NSW Independent  
Planning  
Commission

Pitt Street South  
OSD

INTERNAL AMENITY  
SUBMISSION

18 March 2021  
Final

## FACADE COMPOSITION - NE

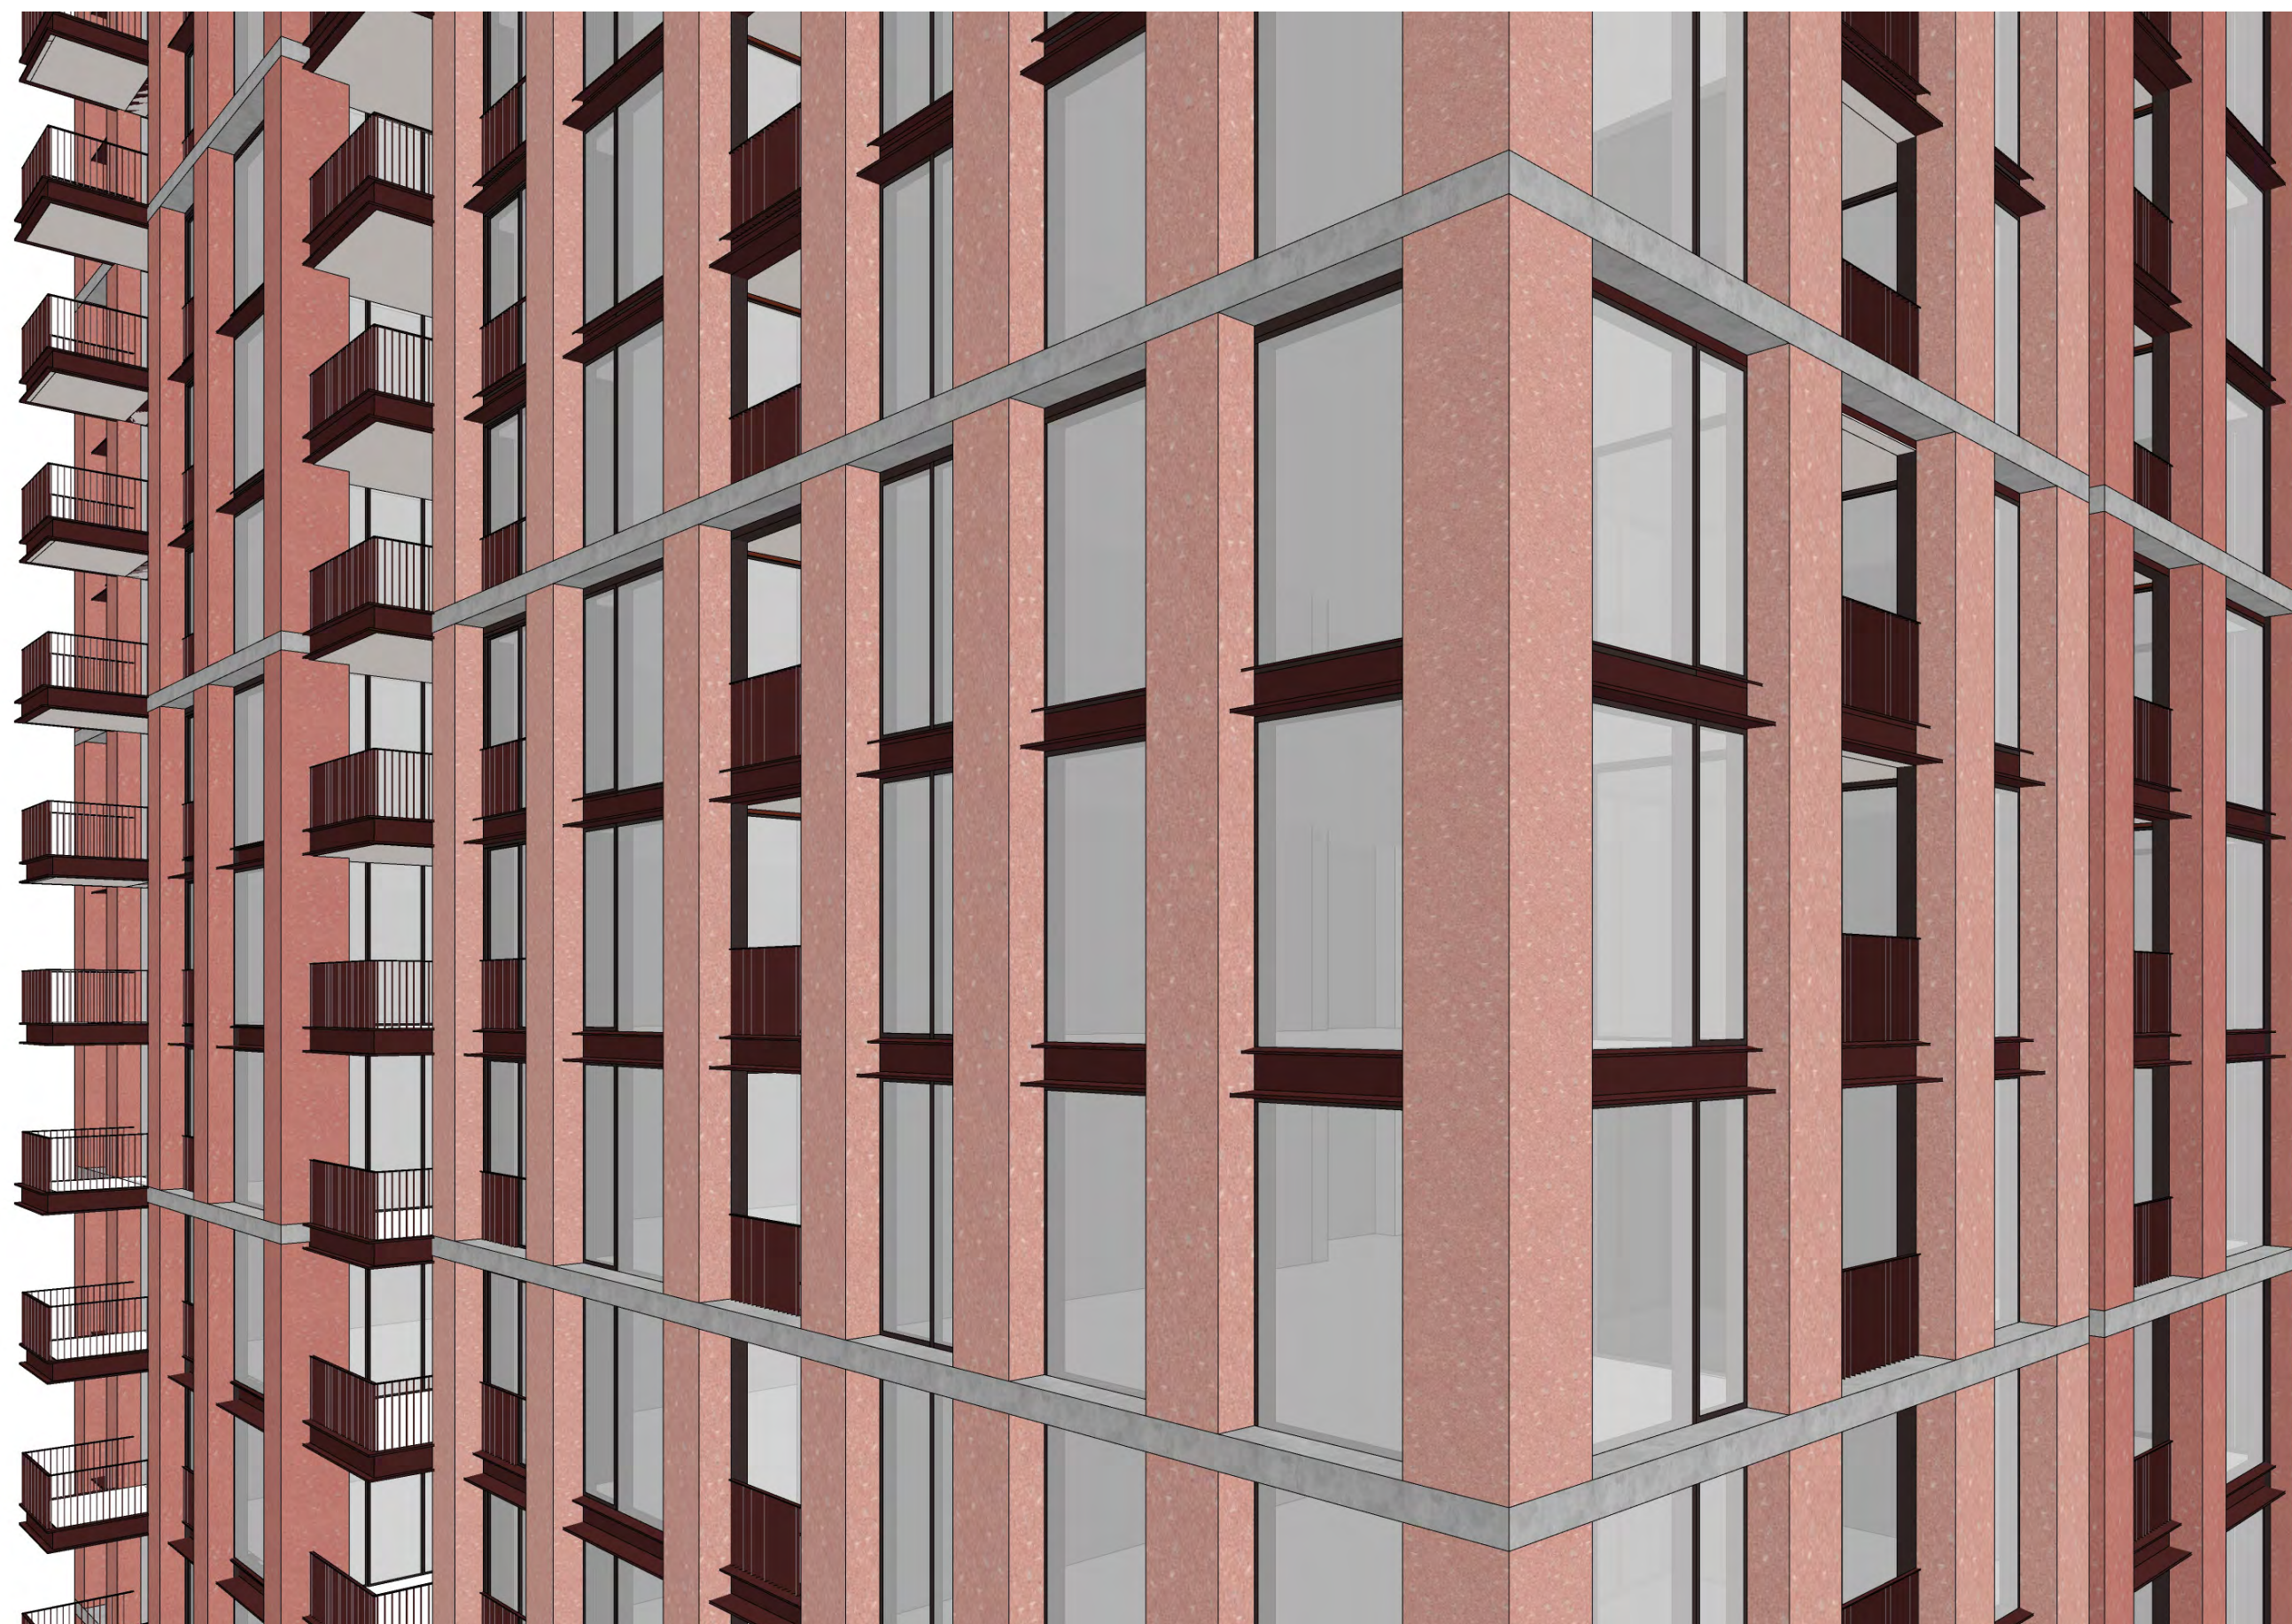
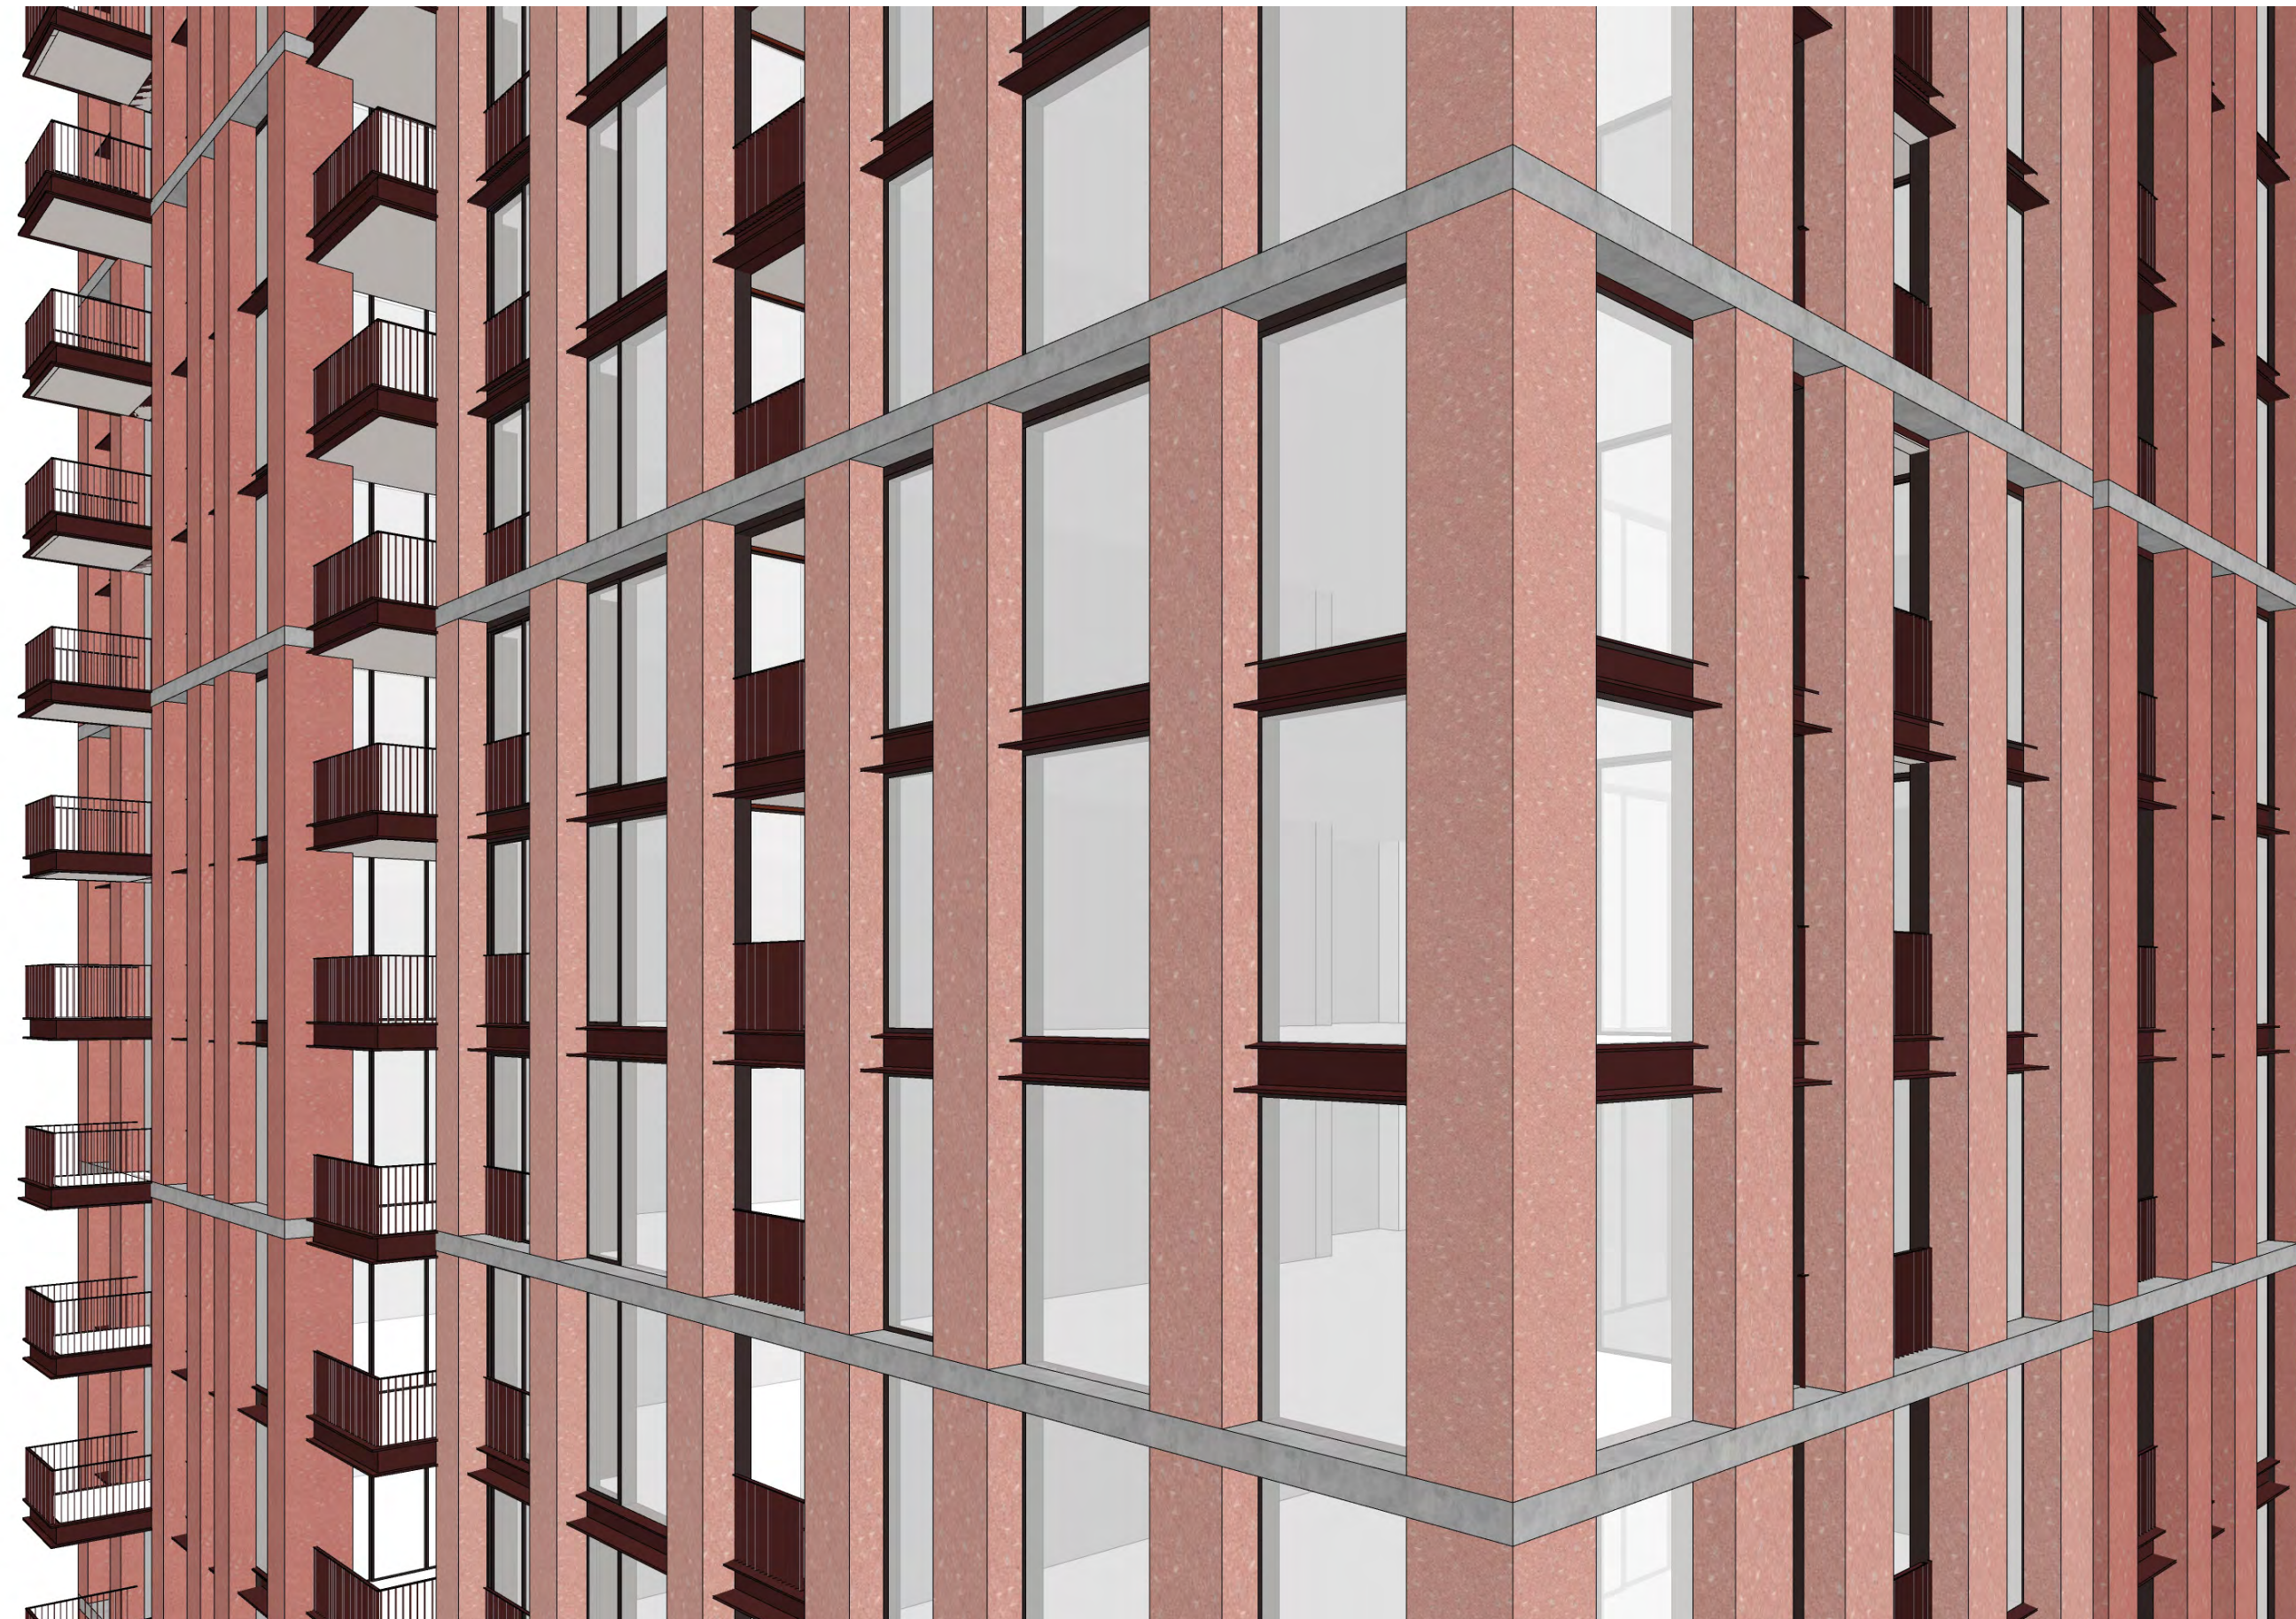
The reduction in columns made to the OSD South façade, presented in DRP 12 and 13, has a significant impact on the overall appearance and visual quality of the building and is not supported by the Panel. Whilst the Panel supports the greater level of consideration that has been given to the rationalisation of window/solid to internal planning, it recommends reviewing the original density and syncopated rhythm of the SSDA proposal, to recapture this design quality.

*One vertical added to living rooms on north east and west facades -  
logic: each face of a volume has one ‘point of compression’*

/39 GRC elements  
/900mm wide  
/400mm deep  
/50mm gap to facade

/44 GRC elements  
/900mm wide  
/400mm deep  
/50mm gap to facade

/39 GRC elements  
/900mm wide  
/400mm deep  
/50mm gap to facade

/44 GRC elements  
/900mm wide  
/400mm deep  
/50mm gap to facade
